PROPOSAL FOR DRAFT AMMEDMENT OF TRANS/WP.29/GRRF/2003/25

Transmitted by the Expert from Japan

Fig1 Exhaust Brake Level

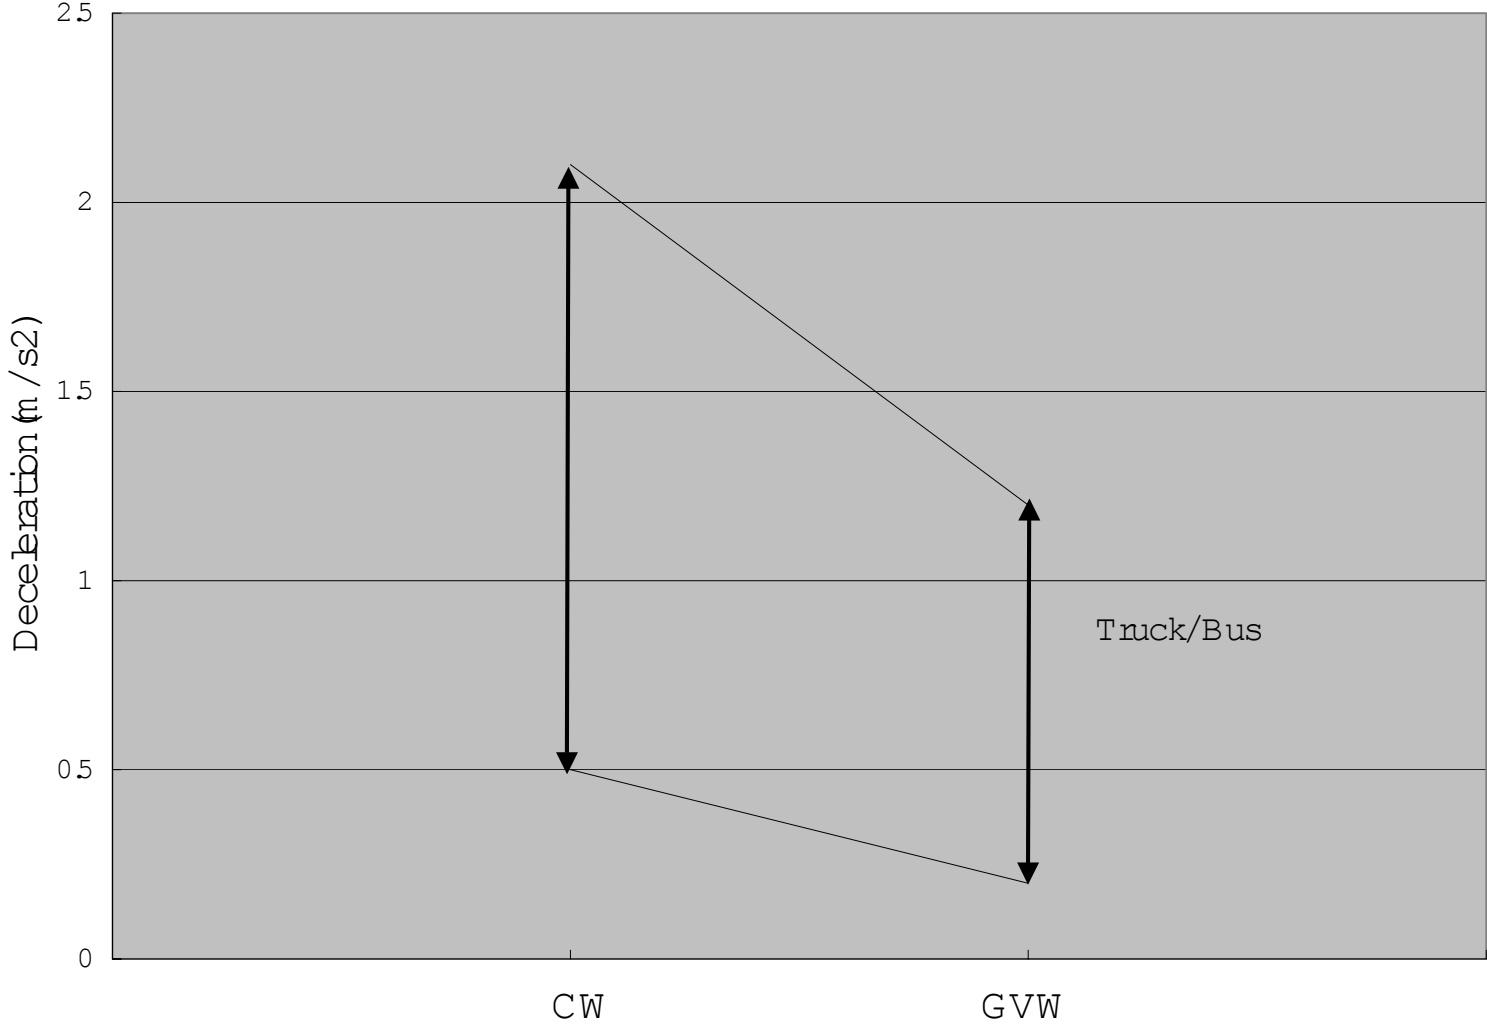
In Japan regulations have already been implemented with a threshold value of 2.2 m/s² at a vehicle speed of 80 km/h following safety investigations.

Data of exhaust brake for trucks is attached.

It shows the deceleration level of the exhaust brake reaches approximately 2.2 m/s² at 80 km/h

5.2.1.30.2 If an endurance braking system is able to generate a retarding force of 2.2 m/s² or more at a vehicle speed of 80 km/h, operation of the system shall generate the signal above.
